**FINAL REPORT  
VALUE ENGINEERING STUDY**

**City of Pueblo  
I-25/Dillon Drive  
Interchange Improvements  
Project**

**June 2013**

**BY SOLUTIONS ENGINEERING & FACILITATING, INC.**

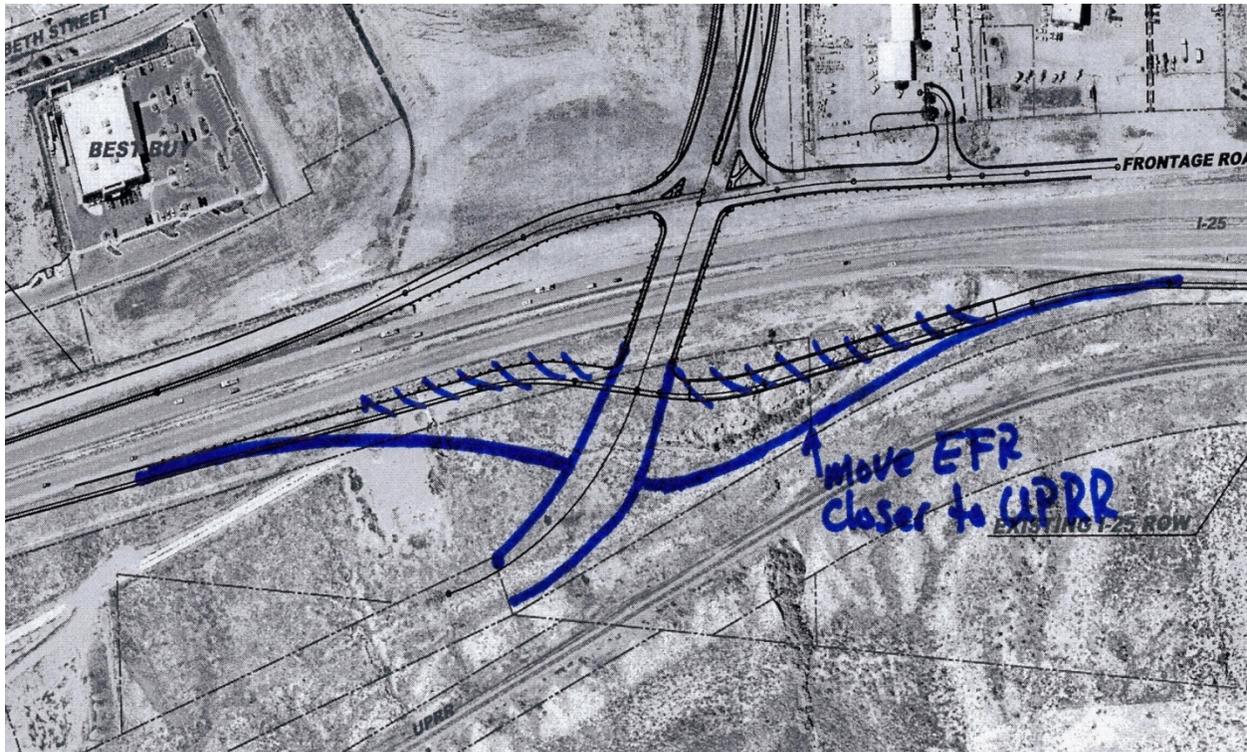
<b>EVALUATION</b>
Idea Number: 01-002 Idea Description: Re-align Dillon Drive east of I-25 to re-align the I-25 off-ramp and the East Frontage Road closer to the UPRR right-of-way (ROW).
Advantages of alternative concept: <ol style="list-style-type: none"><li>1. Reduces grading and bridge/walls required for frontage road.</li><li>2. Incorporates the existing Dillon ROW without impact to adjacent property.</li></ol>
Advantages of original concept: <ol style="list-style-type: none"><li>1. Maximizes distance between off-ramp/frontage road from the UPRR ROW.</li><li>2. Avoids Old Denver Highway.</li></ol>
Risks of implementing alternative concept: <ol style="list-style-type: none"><li>1. Grading at the UPRR ROW line to match existing grade.</li><li>2. Fill of drainage channels east of I-25.</li><li>3. May require lowering Dillon Drive speed limit to make curve work east of bridge.</li><li>4. May impact the Old Denver Highway.</li></ol>

<b>Response to Value Engineering Proposal or Supplemental Recommendation Project:</b>	
<b>Proposal or SR No.:</b>	P01-002
<b>Description:</b>	Re-align Dillon Drive east of I25 to re-align the I25 off-ramp and the East Frontage Road closer to the UPRR ROW.
<b>Recommended Action:</b>	Decline
<b>Discussion:</b>	This would impact the open channel we envisioned and may require the extension of the 6- x 6-ft RCB to its outlet at the UPRR. It would also impact the existing stone stacked culvert located within the railroad ROW below an existing embankment which is the ultimate discharge point Basins C and H.
<b>Construction Cost Savings Comparison</b>	
VE Team Savings Estimate	\$3,100,000
Designer Savings Estimate	\$3,100,000
Reason for Difference in Estimates	N/A
<b>Estimated Design Cost</b>	\$0
<b>Total Cost Savings (Designer Savings Cost Estimate - Estimated Design Cost)</b>	\$0

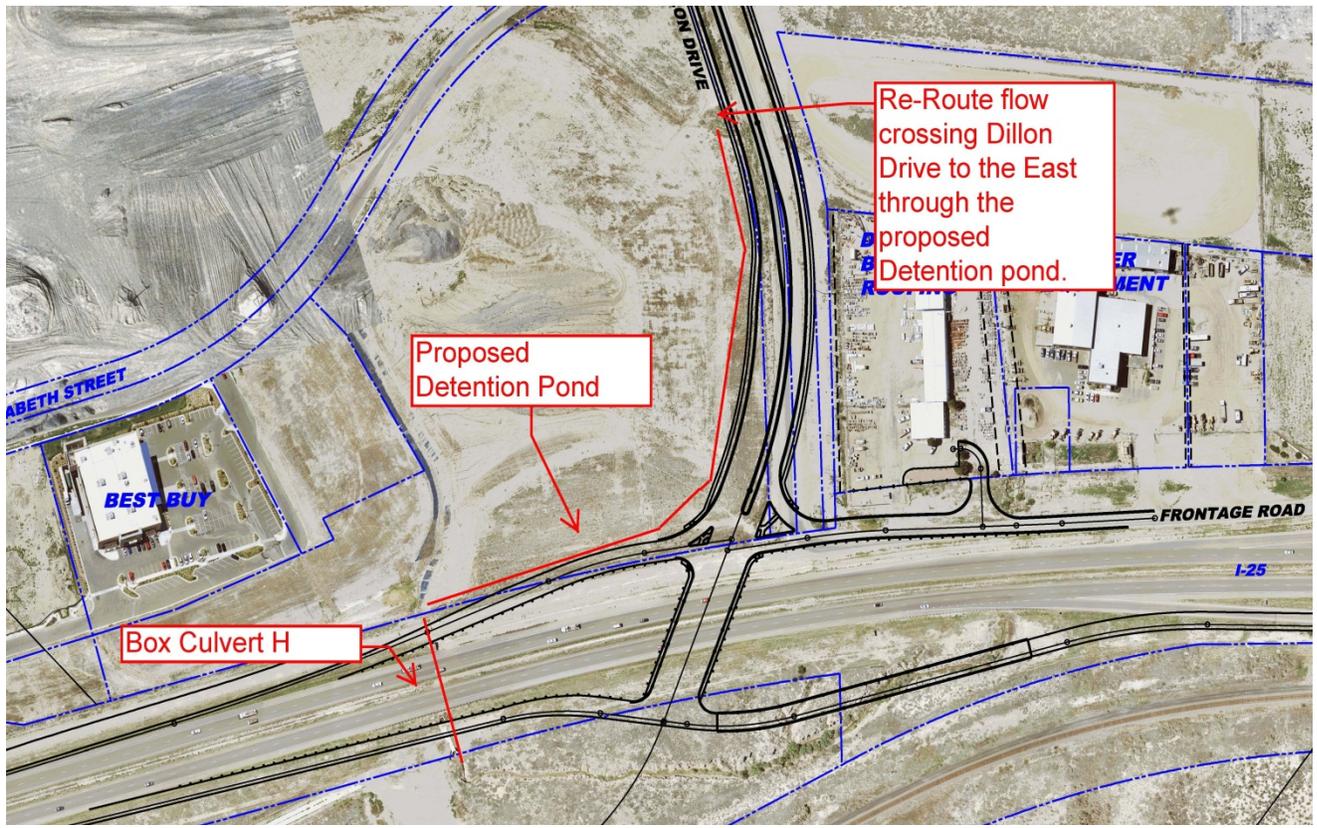
<b>EVALUATION</b>	
Idea Number: 01-011	
Idea Description: Re-route drainage east along the south side of Dillon Drive from the existing corrugated metal pipe (ECMP) to the proposed detention pond and box culvert located on the south side of the proposed Dillon Drive Bridge.	
Advantages of alternative concept:	
<ol style="list-style-type: none"> <li>1. Reduces drainage impact at Box Culvert C (north of Dillon Drive bridge) and for property owners west of I-25.</li> <li>2. Adds increased life by reducing flows to the existing culvert north of Dillon Drive.</li> </ol>	
Advantages of original concept:	
<ol style="list-style-type: none"> <li>1. Keeps flow traveling in the historic spot.</li> </ol>	
Risks of implementing alternative concept:	
<ol style="list-style-type: none"> <li>1. Protecting proposed detention pond from flooding or overtopping.</li> <li>2. May require more capacity through existing culvert south of Dillon Drive bridge.</li> </ol>

The existing box culvert south of the bridge has 36 cfs available capacity for the 100-year storm based on the Drainage Report. The report also indicates that the culverts under Dillon Drive, west of the bridge, do not have enough capacity to pass the 5-year storm to the box culvert north of the bridge; thus a majority of the 100-year storm will bypass to the existing box culvert south of the bridge. The installation/extension of the culverts at Dillon Drive would not be necessary.

<b>Response to Value Engineering Proposal or Supplemental Recommendation Project:</b>	
<b>Proposal or SR No.:</b>	P01-011
<b>Description:</b>	Re-Route drainage east along the south side of Dillon Drive from existing corrugated metal pipe (ECMP) to the proposed detention pond and box culvert located on the south side of the proposed Dillon Drive Bridge.
<b>Recommended Action:</b>	Decline
<b>Discussion:</b>	<p>a. Flows from Basin C are directed today to the existing 6- x 6-ft RCB north of Dillon Drive not to the existing 6- x 4-ft RCB south of Dillon Drive. To change the point of discharge could result in flooding properties which are not flooding today and, at a minimum, the impact of this flooding would need to be evaluated and permission obtained from all property owners would be needed.</p> <p>b. The pond is a water quality pond by the 6- x 4-ft RCB, not a detention pond, and does not attenuate flows. A large area and volume would be required for a detention pond which would attenuate flows. I do not know if this volume could be provided easily within the existing topography. This cost was not considered in the evaluation.</p> <p>c. Re-directing flows to the 6- x 4-ft RCB would mean (assuming all of Basins H and C3 are directed to this RCB) would mean over 600 cfs would be delivered to the 6- x 4-ft RCB, well in excess of its capacity. CDOT has determined the 6- x 6- ft RCB can pass the flow at a head exceeding CDOT standards.</p>

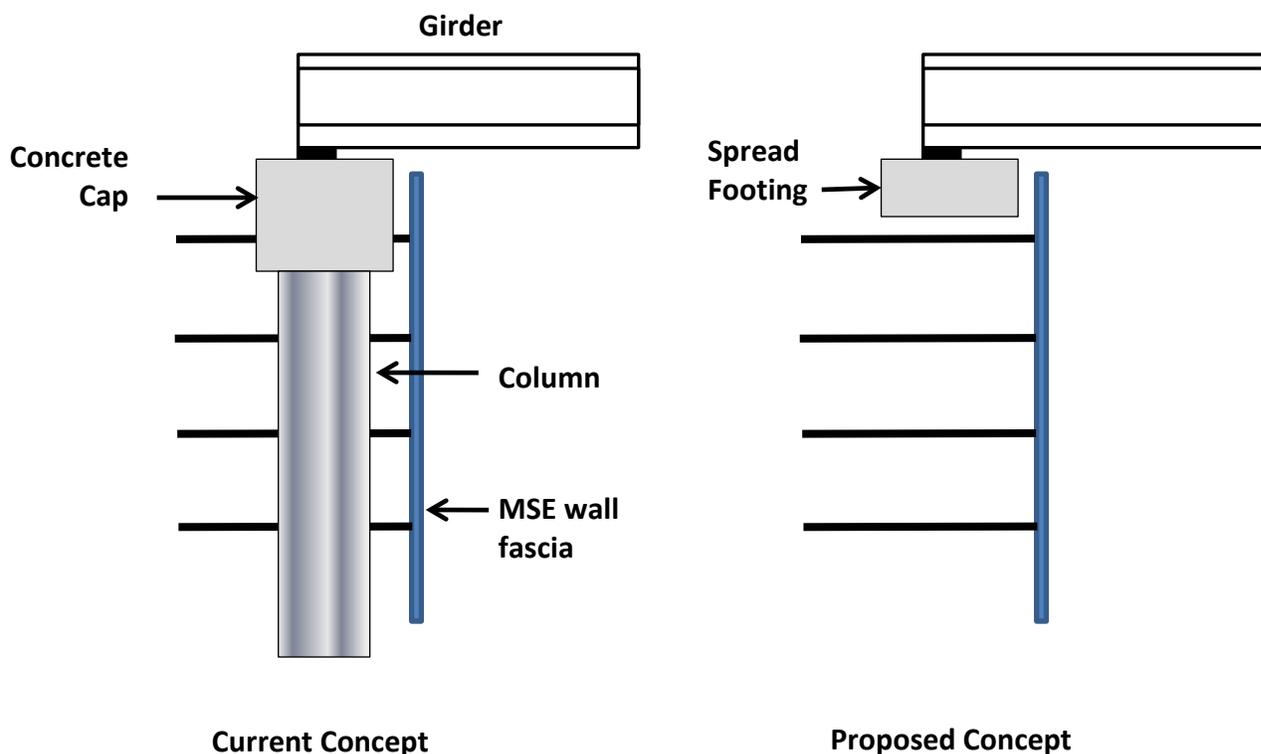
<b>EVALUATION</b>
Idea Number: 01-023 Idea Description: Provide a separate pedestrian structure over I-25 and narrow the Dillon Drive Bridge.
Advantages of alternative concept: <ol style="list-style-type: none"><li>1. Narrower bridge deck</li><li>2. Could use historic bridge available locally</li><li>3. Pedestrian bridge may be less expensive to aesthetically treat</li><li>4. Increased safety, pedestrian, and cyclist are separated from traffic</li><li>5. Opportunity to delay cost of pedestrian bridge until future date</li></ol>
Advantages of original concept: <ol style="list-style-type: none"><li>1. Typical City cross-section</li><li>2. Provides a pedestrian crossing where it is expected along the arterial roadway</li></ol>
Risks of implementing alternative concept: <ol style="list-style-type: none"><li>1. Public may not want another structure over I-25</li></ol>

1. Revise the current 12-foot lane width to 11 feet  
Total reduction in bridge width = 1 ft x 6 lanes = 6 feet
2. Eliminate 1 girder line
3. Reduce deck quantities, assume 9" average deck thickness
4. Neglect reductions in abutment, pier cap and foundation quantities

<b>Response to Value Engineering Proposal or Supplemental Recommendation Project:</b>	
<i>Proposal or SR No.:</i>	P01-023
<i>Description:</i>	Provide a separate pedestrian structure over I-25 and narrow the Dillon Drive Bridge.
<i>Recommended Action:</i>	Decline
<i>Discussion:</i>	City does not want separate structures to maintain.
<b>Construction Cost Savings Comparison</b>	
VE Team Savings Estimate	\$2,500
Designer Savings Estimate	\$0
Reason for Difference in Estimates	N/A
<i>Estimated Design Cost</i>	\$0
<i>Total Cost Savings (Designer Savings Cost Estimate - Estimated Design Cost)</i>	\$0

**Current Concept**

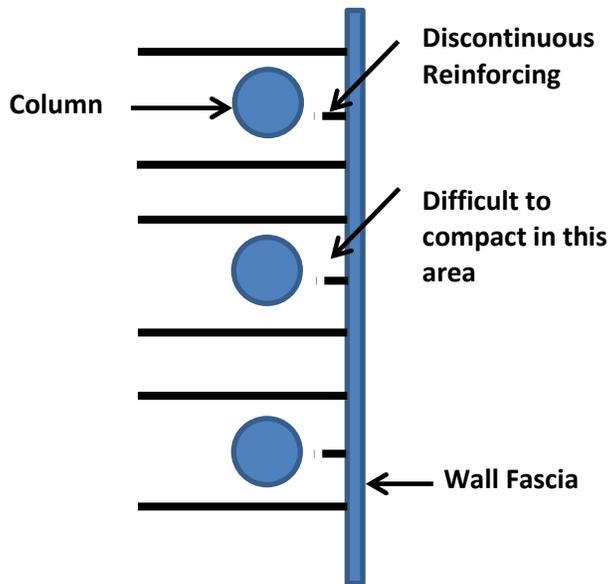
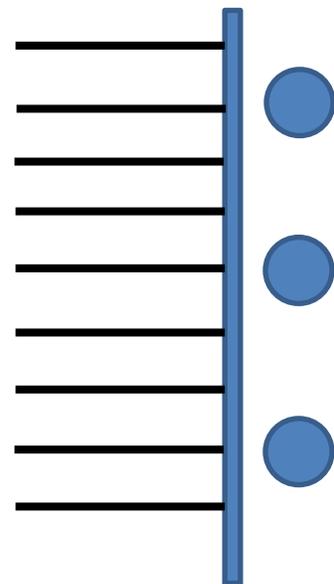
<b>EVALUATION</b>
Idea Number: 01-005 Idea Description: Construct bridge abutment foundations outside of the MSE abutment walls.
Advantages of alternative concept: 1. Reduces risk of MSE wall failure 2. Improved constructability of the MSE walls 3. Reduced construction inspection requirements 4. Slight reduction in MSE wall quantity and costs (too small to quantify)
Advantages of original concept: 1. Possibly better aesthetics
Risks of implementing alternative concept: 1. None noted.

1. Where the columns conflict with MSE reinforcing, a special detail is required to transfer the tributary load from the “missing” reinforcing to adjacent reinforcing strips.
2. Compaction between the CIP column and soil face of wall fascia is very difficult.

These constructability issues have historically been the cause of MSE wall failures (distortion of wall panels leading to settlement of the MSE backfill).

<b>Response to Value Engineering Proposal or Supplemental Recommendation Project:</b>	
<i>Proposal or SR No.:</i>	P01-005
<i>Description:</i>	Construct bridge abutment foundations outside of the MSE abutment walls
<i>Recommended Action:</i>	Decline
<i>Discussion:</i>	No cost savings
<b>Construction Cost Savings Comparison</b>	
<b>VE Team Savings Estimate</b>	\$0
<b>Designer Savings Estimate</b>	\$0
<b>Reason for Difference in Estimates</b>	N/A
<i>Estimated Design Cost</i>	\$0
<i>Total Cost Savings (Designer Savings Cost Estimate - Estimated Design Cost)</i>	\$0

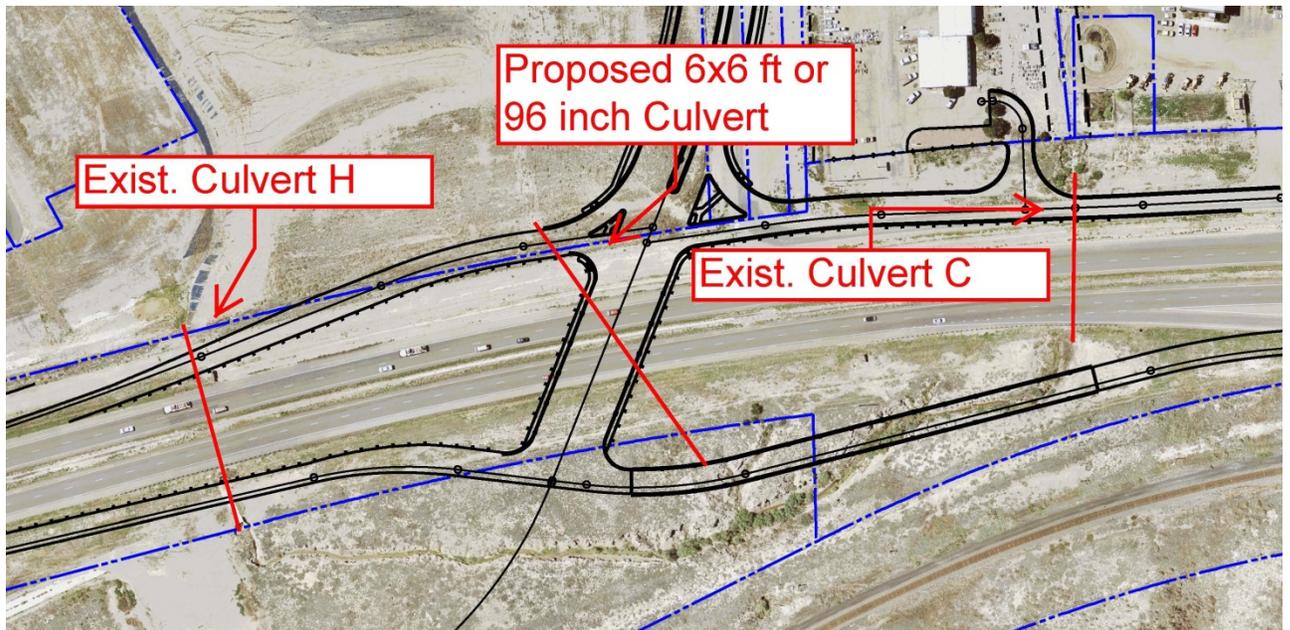
<b>EVALUATION</b>	
Idea Number: 03-004	
Idea Description: Add an additional box culvert to accommodate excess 100-year flows not able to be conveyed by the current infrastructure at Design Points C and H.	
Advantages of alternative concept:	
<ol style="list-style-type: none"> <li>1. Provides additional capacity to reduce chances of flooding at existing culverts.</li> <li>2. Provides increased safety on I-25.</li> </ol>	
Advantages of original concept:	
<ol style="list-style-type: none"> <li>1. Does not require boring/open cut across I-25.</li> </ol>	
Risks of implementing alternative concept:	
<ol style="list-style-type: none"> <li>1. Additional costs related to new structure, crossing Interstate, and repairing Interstate.</li> </ol>

The proposed remaining flow of the 100-year flows that do not fit into the existing culverts is 438-cfs. An additional 6x6 concrete box culvert (or equivalent 96-inch pipe) will provide conveyance of these proposed flow rates.

<a href="#">SR03-004</a>	Add an additional box culvert to accommodate excess 100 year flows not able to be conveyed by the current infrastructure at Design Points C and H.	<b>D. Elsner</b>	<b>Decline</b>		
<a href="#">SR01-029</a>	Provide 3" Hot Mix Asphalt overlay on Dillon Dr. bridge deck.	<b>K. Fredell</b>	<b>Accept</b>

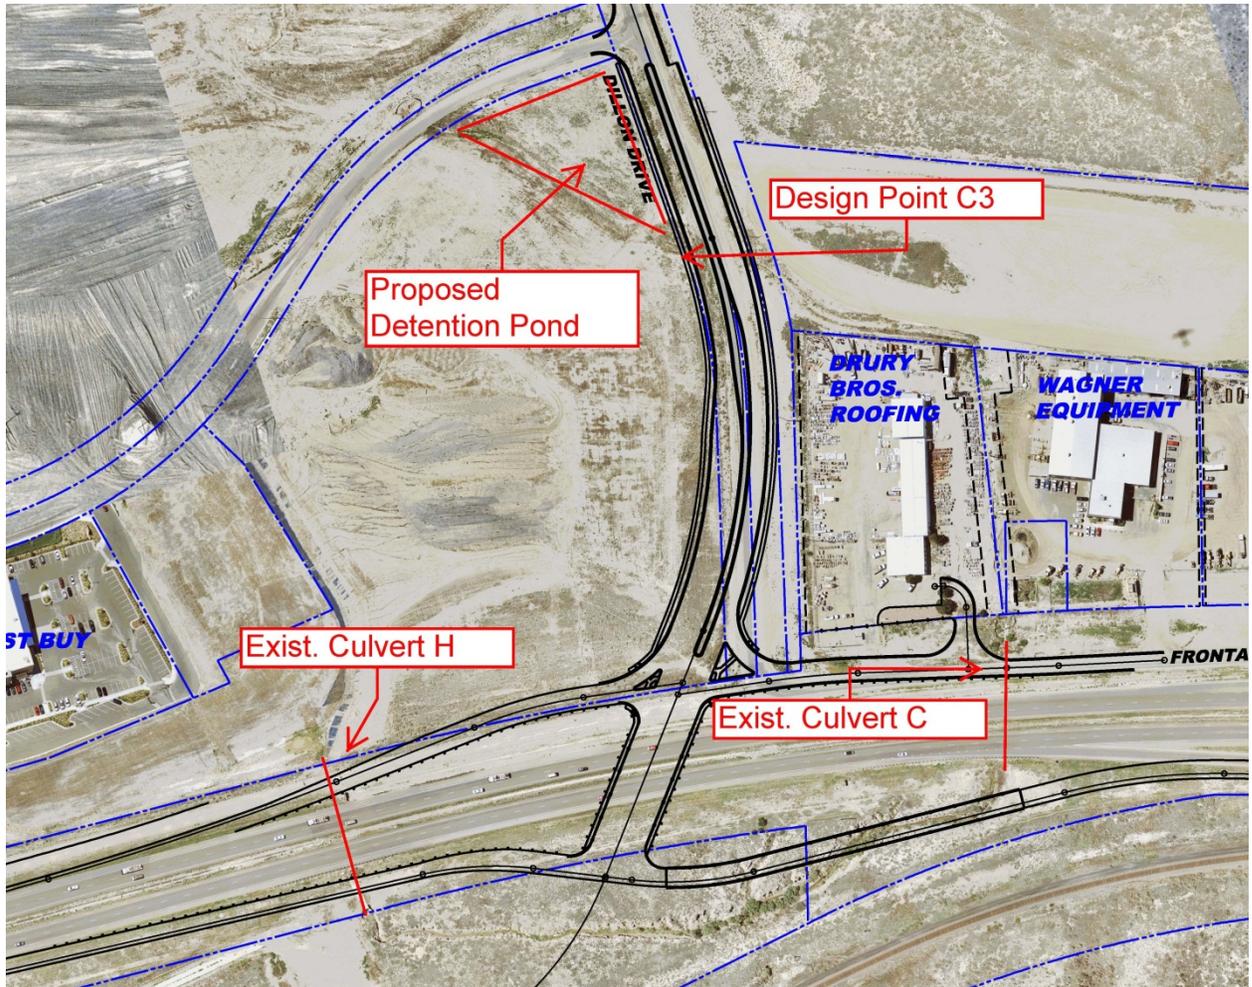
<b>EVALUATION</b>
Idea Number: 01-010 Idea Description: Provide a detention pond at the southeast side of intersection of Dillon Drive and Elizabeth Street to attenuate flows for the box culverts at I-25.
Advantages of alternative concept: <ol style="list-style-type: none"><li>1. Reduce/attenuate drainage flows from design point C3 and overall impact at I-25 Box culvert crossing.</li><li>2. Reduces overall impact to downstream drainage system and possible reduction of storm infrastructure.</li></ol>
Advantages of original concept: <ol style="list-style-type: none"><li>1. No proposed detention pond in this location</li><li>2. Potential commercial site.</li></ol>
Risks of implementing alternative concept: <ol style="list-style-type: none"><li>1. Private Landowner would need to dedicate or sell property.</li><li>2. Increased maintenance of facility.</li></ol>
Conclusion: Do not propose this idea because due to proposed high cost (\$202,000) and high risk of drainage structure location.

The cost to add the detention pond is approximately \$202,000 and the benefit would be to reduce drainage flow from the existing box culverts north and south of the existing bridge. This would assist in the passing of the 100-year storm, reduce sediment loading, and maintenance of the existing box culverts.

**Additional Concrete for Multi-Use Path**

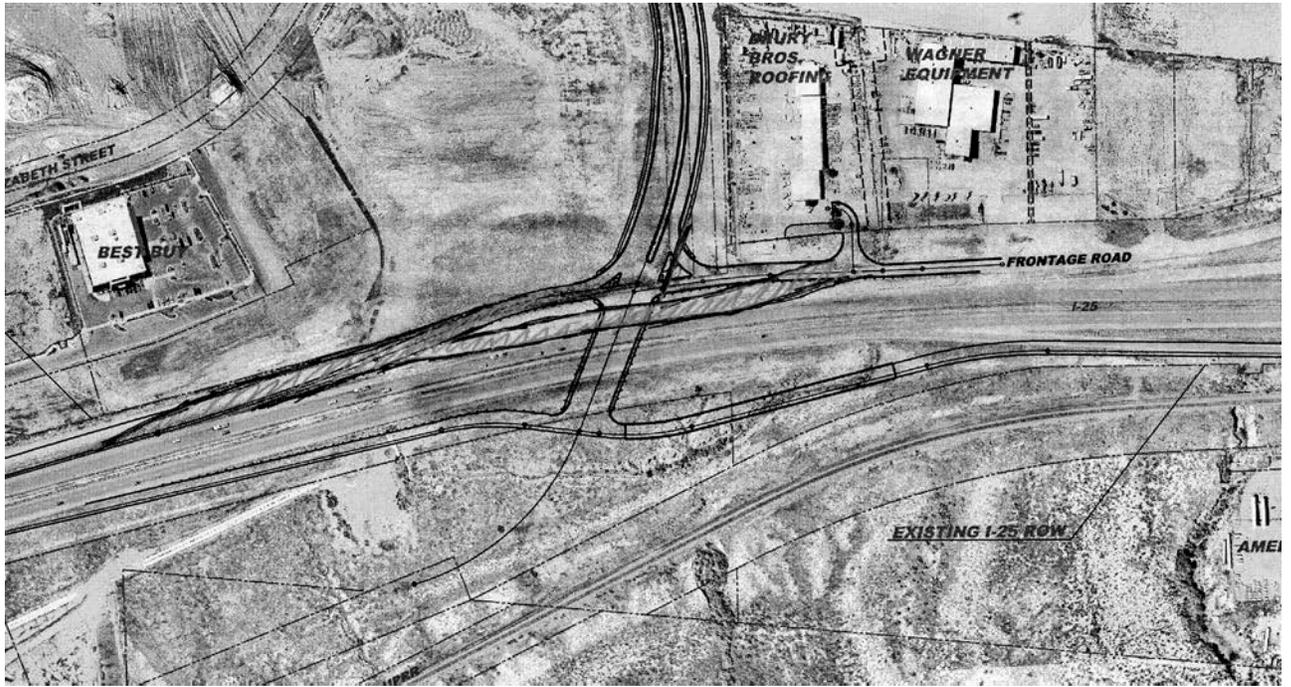
<b>EVALUATION</b>
Idea Number: 01-037 Idea Description: Use multi-use paths in lieu of bike lanes across bridge and along Dillon Drive.
Advantages of alternative concept: 1. Narrower bridge deck. 2. Savings from less asphalt and base.
Advantages of original concept: 1. Project provides separate bike lanes and sidewalks
Risks of implementing alternative concept: 1. Politically unacceptable 2. Revised section would not meet current standards
Conclusion: Do not propose this idea because it was determined to be unfeasible.
